From: Collin Van Slyke <collin@nwecological.com>
Sent: Tuesday, December 10, 2024 4:54 PM
To: Bowker, Kristina J.
Cc: Dearborn, Amy C.; Sundin, Steven C.; Eddie & Clover Goodsir
Subject: HE-24-PL-027 Mitigation Plan
Attachments: Mitigation Map Nov 2024.pdf; Goodsir.AlabamaSt.MitPlan.complete112624.1.pdf

2302 Alabama St
(Parcel #380320540078)
Conceptual Mitigation Memo

CRITICAL AREAS IMPACT ASSESSMENT & MITIGATION PLAN

2302 ALABAMA STREET
PARCEL #380320540078
BELLINGHAM, WA

Stream Buffer Impact/Enhancement Map

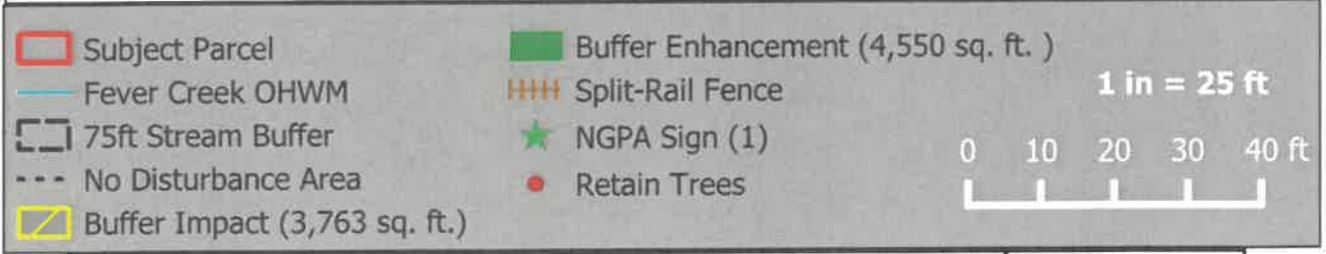
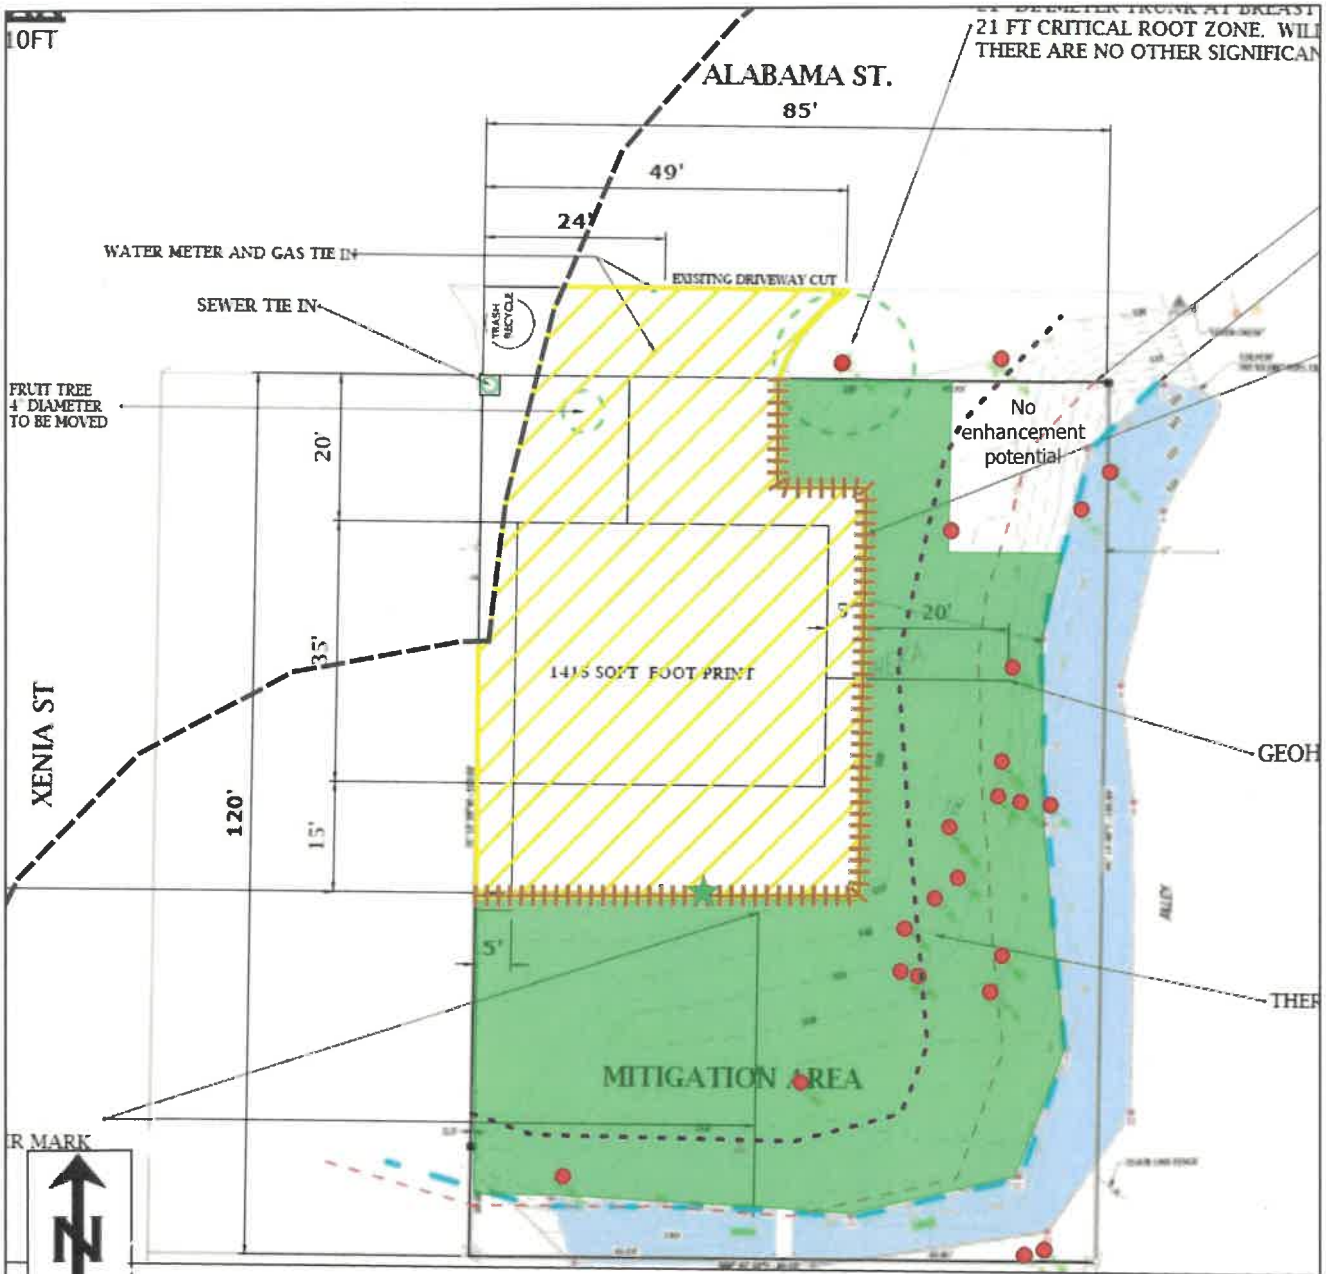
In reviewing the materials available on the HE website, I discovered the mitigation plan included as Attachment I is outdated and based on a previous site plan. The site plan included as Attachment A is correct, and we prepared an updated mitigation plan in November to reflect this, but it appears it did not make it into the record.

As a result, the buffer impact (4,020 sf) numbers included in the staff report and other materials are outdated (should be 3,763 sf). All other project details remain unchanged.

I've attached the November Mitigation Plan and Map which show consistency with Attachment A (site plan). I'll be in attendance at the hearing tomorrow to answer any questions.
